Office Action Summary

10/511,071

JONES, STEVEN VICTOR

DETAILED ACTION

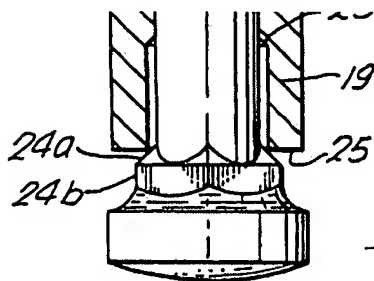
Re claims 1-3, 21-23: Palm teaches a blind rivet assembly comprising:

- An elongate tubular body 1 with a shank about a shank axis (Fig 7) and preformed head 7 at first end, and an expandable portion 17 at opposite end from head, said expandable portion defining 3 slots (Fig 9 or 14) that define a triangular aperture having substantially flat sides, noting that substantially flat includes that the side are convex (Figs 9 and 14). The slots are equally spaced about the tubular body circumference as described in claim 3 (Fig 9 and 14).
- There is a mandrel 2 having a coaxial substantially smooth stem and having a

head with maximum external diameter greater than internal diameter of tubular body, (Fig 5), said head having a shoulder portion engagement surface perpendicular to the stem,

- and at least one of said [three] slots increases in width in a radial direction as it extends from tubular body outer surface to inner surface of said shank, and the substantially flat sides tangentially engage the mandrel (Fig 9, 14)

Re claim 9 and 29: Mandrel stem with a circular cross-sectioned reduced diameter section adjacent shoulder portion is taught in Palm (see marked up figure above), in Lacy as 24a and in Dawdy as section between 98 and 96.

shoul-der (shōl-der) noun

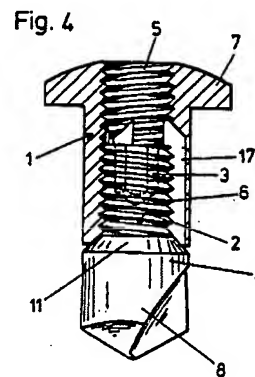
6. An angled or sloping part, as: a. The angle between the face and flank of a bastion in a fortification. b. The area between the body and neck of a bottle or vase.

7. The area of an item or object that serves as an abutment or surrounds a projection, as: a. The end surface of a board from which a tenon projects.¹
